ACER Decision on the ERAA 2021: Annex I

DECISION No 02/2022
OF THE EUROPEAN UNION AGENCY
FOR THE COOPERATION OF ENERGY REGULATORS
on the European Resource Adequacy Assessment for 2021
Technical annex

22 February 2022

Figure 13: Assumptions for meeting the balancing reserves requirement per bidding zone in 2025

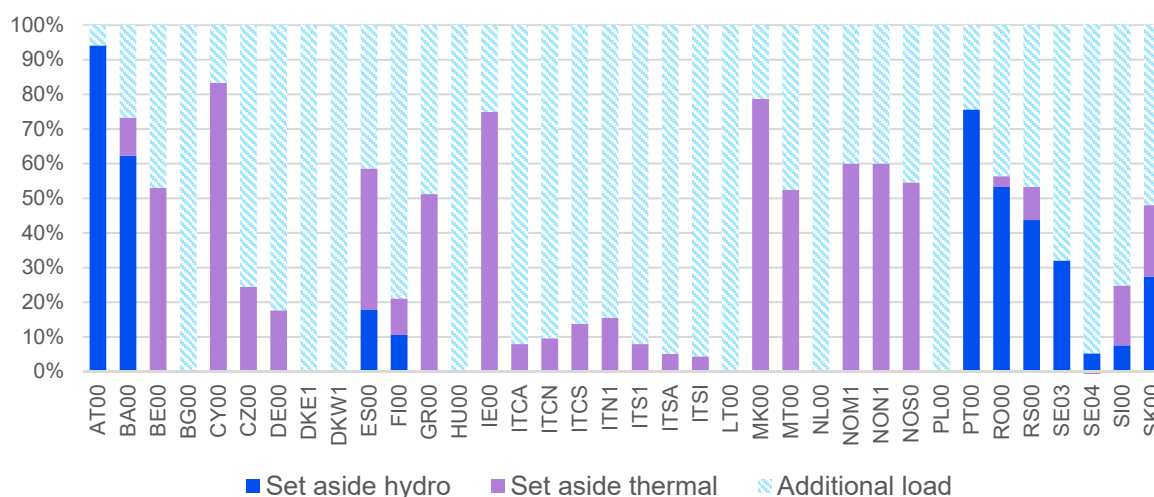
Figure 13 presents how Member States are assumed to meet their reserve requirement across the three types of resources in 2025. It shows that a few Member States are projected to meet their needs through primarily hydro capacity, while in most, the needs are met through a combination of different resource types. In several Member States, the reserve requirement is added as additional load, in full or partially.

While the current approach is in line with the ERAA methodology, ACER believes it unnecessarily distorts the results of the assessment. Therefore, ACER recommends that future assessments treat balancing reserves outside the economic dispatch, or in other words the assessment allocates the reserve requirement to specific capacities and does not treat it as added load (high priority). Such an approach would effectively imply that such resources would make sufficient revenues to be economically viable.⁹⁵

Figure 14: Reserve requirement as added load compared to average peak and off-peak demand (2025 assumptions)

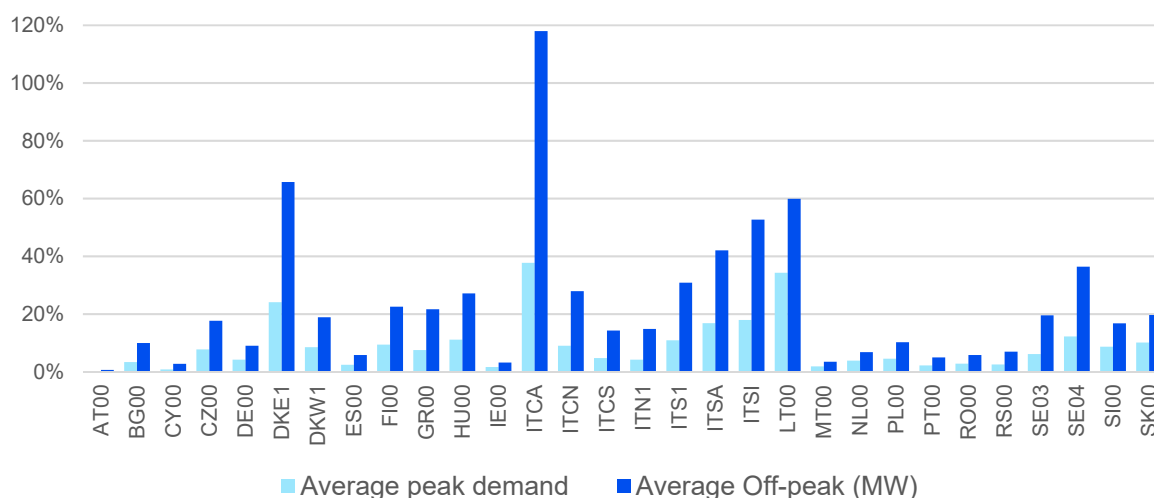
- On the one hand, it can affect market prices in the economic dispatch modelling. In general, this simplification is expected to drive prices up. By adding load, the optimization algorithm will possibly clear at a higher value than if the reserve requirement was treated outside the energy market. Particularly, this would be the case if the resources serving as balancing reserves were high in the merit order, i.e. have a high short-run marginal cost. ACER expects this approach to affect prices depending on the relative size of the added load in relation to the demand levels; the higher the relative size of the added load, the greater the potential impact on prices. Figure 14 shows the added load, due to the reserve requirement, as a share of the average peak and off-peak demand across all climate years. The added load is particularly prominent in smaller bidding zones, compared to larger ones.

- On the other hand, this simplification conceals revenues that resources reserved by the system operator for balancing purposes would earn through capacity payments. Resources providing ancillary reserves, particularly FCR and FRR, would normally receive an availability payment (in €/MW for being available to the system operator) and a utilization payment (in €/MWh, reflecting their short-run marginal cost). The ERAA 2021 essentially omits entirely the availability payments these resources would receive, thus undermining their profitability in the assessment.

- The addition of balancing reserves requirements as load can have a further negative impact on resources with limited energy capabilities, such as storage. The additional load requires an equivalent amount of energy for supply to meet demand. If this additional production is met by resources with limited energy capabilities, it could deplete their available energy, and thus undermine their contribution to resource adequacy. In reality this capacity resource would not produce such an amount of energy but rather be set aside, to deal with any sudden and short-lived disturbances in the system.

Figure 15 Number of different Fmax values on considered CNECs

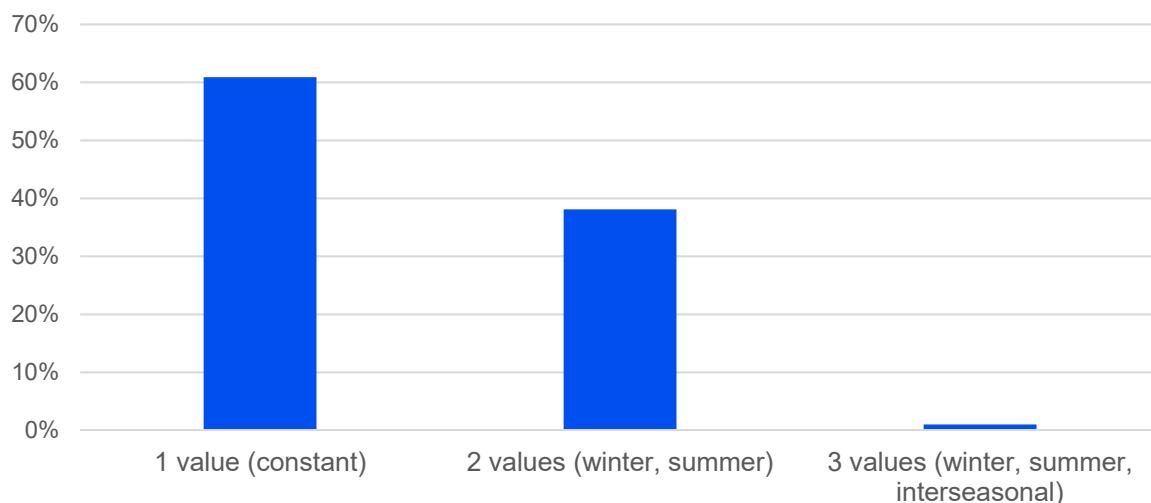
Figure 15 shows, for all considered CNECs, the number of different Fmax values used for the full year. Despite the ERAA methodology requiring at least seasonal calculation of cross-zonal capacities,¹¹⁰ only one Fmax value applied for most CNECs. Some CNECs applied two values per year, while only 1% of CNECs also defined an “interseasonal” value.

Regarding the fourth step, associated with the estimation of RAM, ACER expects ENTSO-E to at least introduce seasonal Fmax values on all CNECs, which change Fmax between seasons (high priority), and to consider reflecting more detailed variations of Fmax, e.g. when dynamic line rating is expected to apply (low priority). ACER also expects ENTSO-E to provide appropriate data to enable oversight of the RAM estimates (high priority).
